UNITED STATES PATENT AND TRADEMARK OFFICE

10/802,640

Office Action Summary

DETAILED ACTION

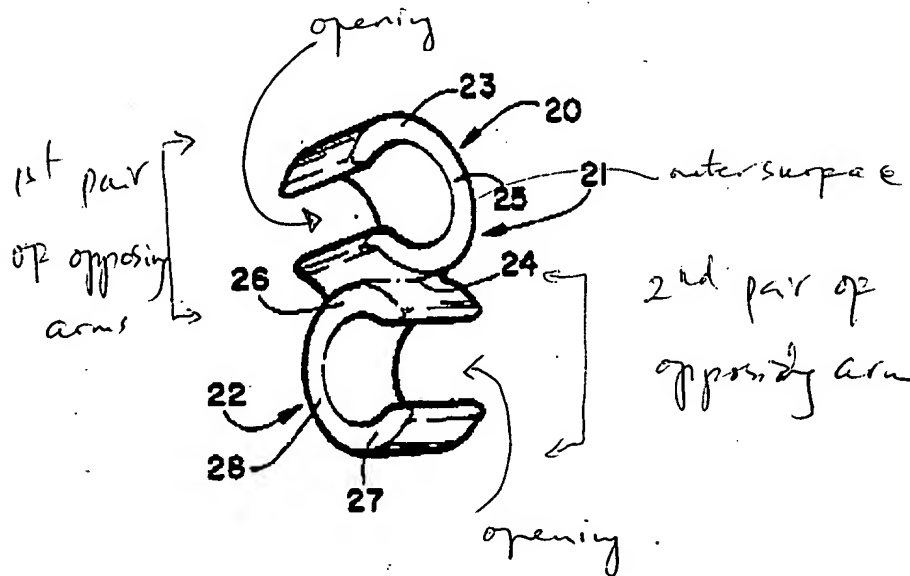
Claims 1, 4-7, 16 and 20 are rejected under 35 U.S.C. 102(b) as being anticipated by US patent No. 5,371,991 to Bechtel et al.

As to claims 1,4-7, 16 and 20, Bechtel et al teaches a re-bar clamp assembly (Fig. 2) comprising all the limitations as claimed in claims 1, 4-7, 16 and 20 as shown on

the attached Figure 2. With regards to claim 7, the material of the clip, Bechtel et al also discussed on col. 2, line 68 and col. 3, lines 1-4) as being made out of plastic.
